# **RAS Civil Engineering, LLC**

Re: **Development Plan Application Control Number 201909040046**

We are in receipt of the City's comment letter dated 9/17/19 and offer the following responses:

CAR SOURCE  
LIGHTING LAYOUT

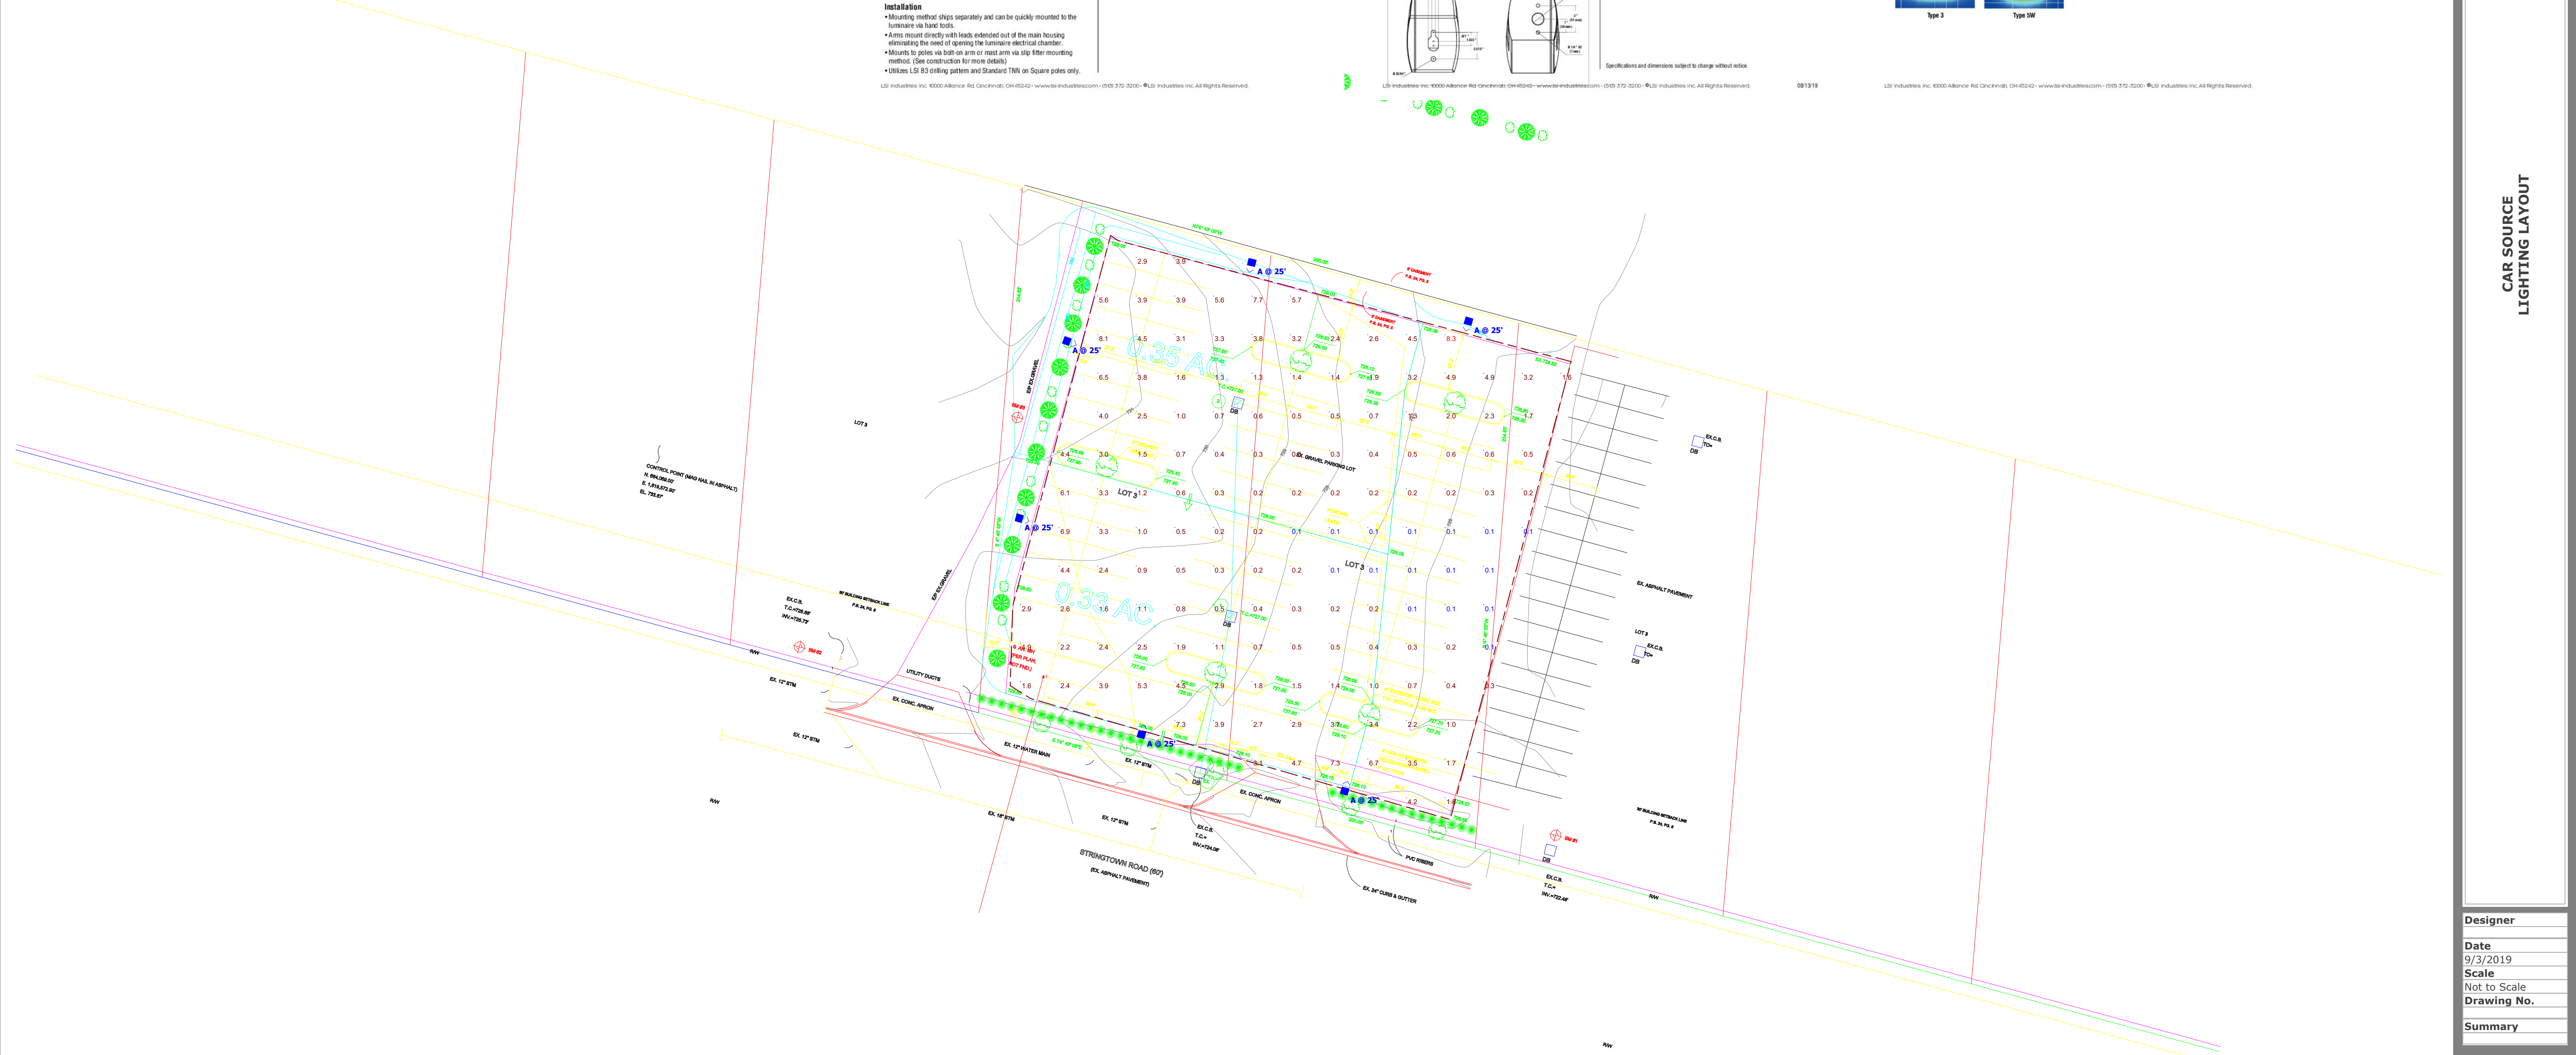
- 8) Site lighting has been adjusted to meet the requirements.
- 9) In making the adjustments, there has been a site light added to an interior island.
